**Subject** ➤ Addition of Washer 4 and change of Screw 5

**For Models** ➤ 1050D

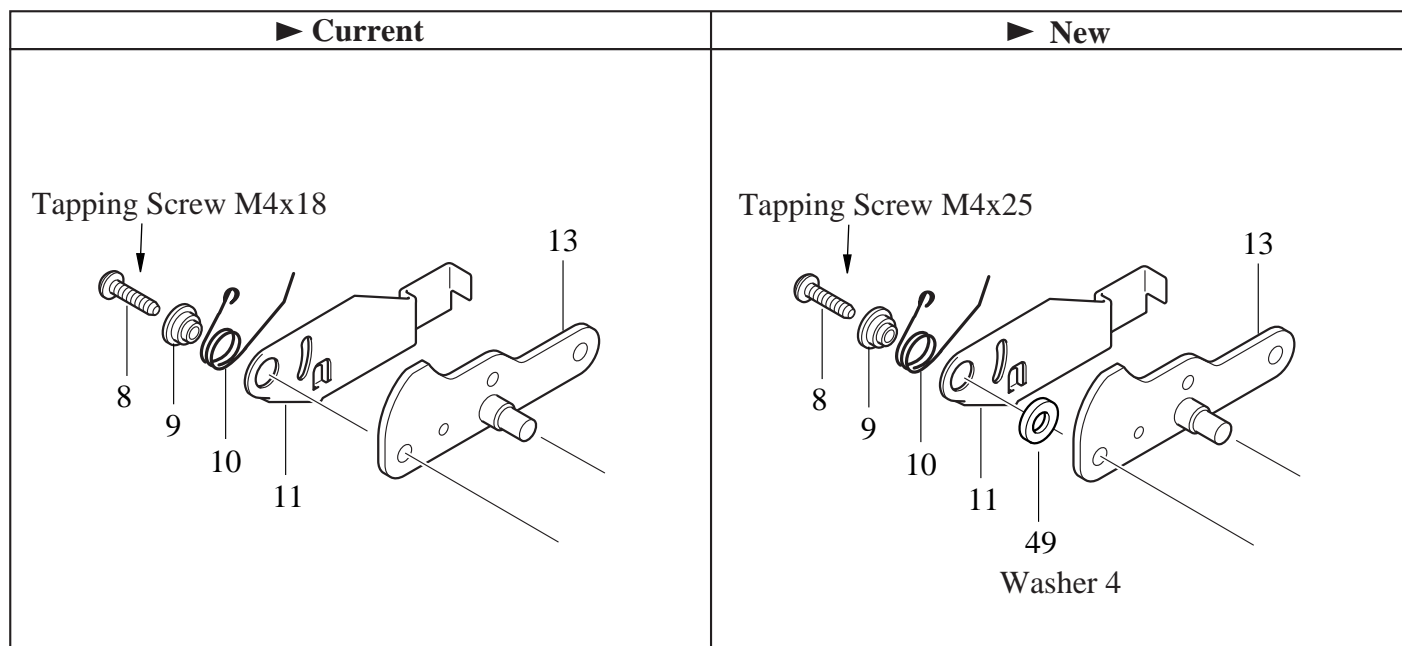
**Description** ➤ As illustrated below, Washer 4 has been added for improvement of endurance, accordingly Tapping screw has been changed.

Item No.	Current part		Q'ty	I/C	New part		Q'ty	Note
8	Tapping Screw M4x18 265995-6		1	<=	Tapping Screw M4x25 265999-8		1	
25	Pan Head Screw M4x25 9111148-2		1	<=	Pan Head Screw M4x30 9111158-9		1	For attaching Set Plate
49					Washer 4 941051-3		1
